MEMORANDUM FOR: Ernst Volgenau, Director, IE  
FROM: Thomas J. McTiernan, Director, OIA  
SUBJECT: SURRY UNIT NO. 1 NEUTRON SHIELD TANK

EXHIBIT B

ABOVE FIGURE 11.2.25-1 IN PSAR - BELOW - AS-BUILT.

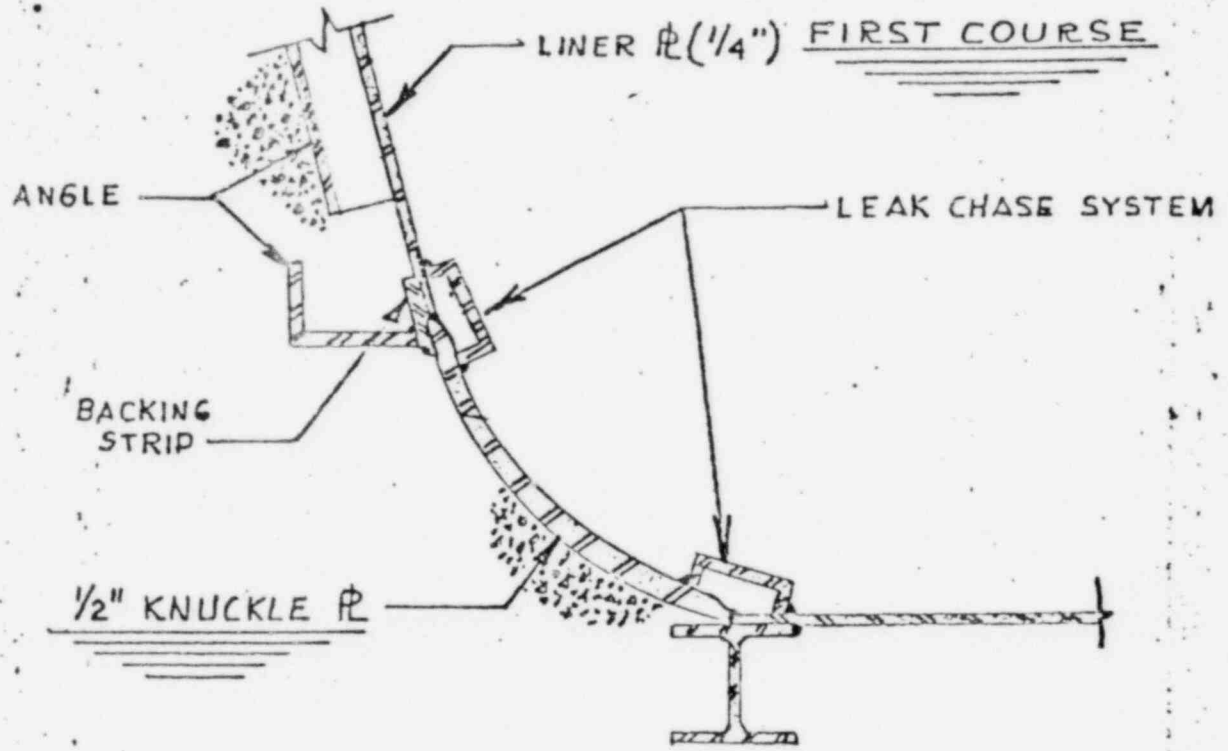
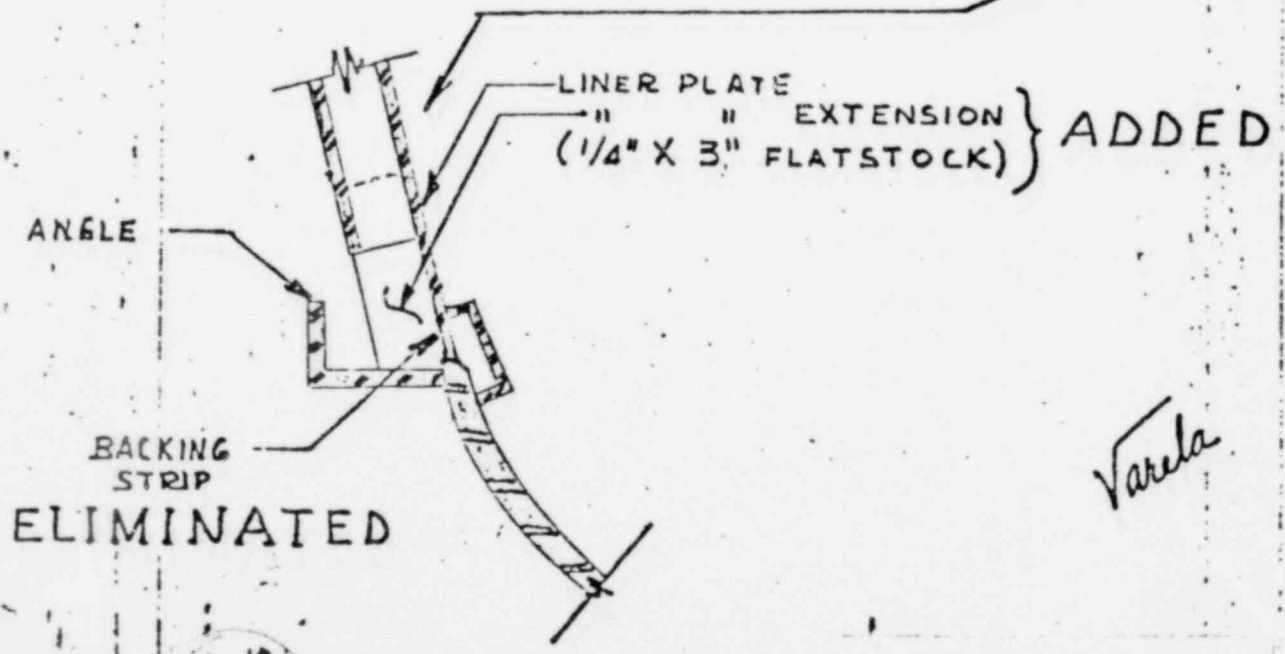
NO RECORD OF ENGINEERING APPROVAL FOR THE REMOVAL OF THE BACKING STRIP

- 2. The liner assembly joint where the 1/4-inch plate is welded to the 1/2-inch knuckle section does not have a backing strip as shown on Supplement No. 4, Figure 11.2.25-1 of the PSAR. ~~This appears to present no problem to this inspector,~~ but is considered as a deviation from the PSAR only. AP&L states that the discrepancy will be corrected by PSAR supplement as the above items were corrected.
